Spelthorne Borough Council, Local Plan review- Strategic Flood Risk Assessment (SFRA) Level 1 and 2

We have reviewed the SFRA Level 1 and 2, Word document from Aecom (*EA comments SBC doc*) and *Examples of possible wording to be added to site allocations within the Spelthorne Local Plan*).

Screenshot 1

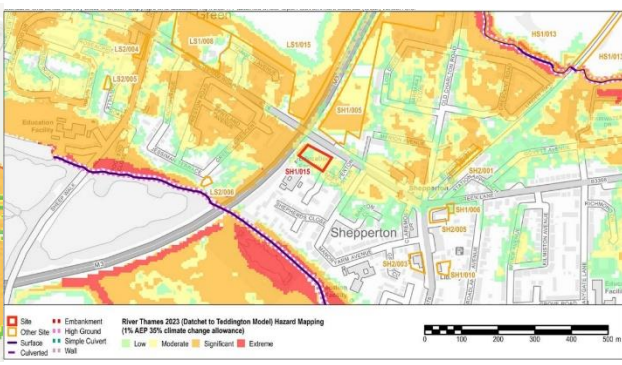
We previously mentioned the outlines did not appear correct in Appendix B, in the response you mentioned that these were corrected. However, we have double checked, and there appears to be an issue still. Please see below to better indicate this. For SH1/015 the site the hazard is also shown to include Danger for most as shown is screenshot 1, rather than danger to some as shown in screenshot 2. We have noticed several sites where the hazard does not appear to represent the risk correctly. Please can you check the mapping.
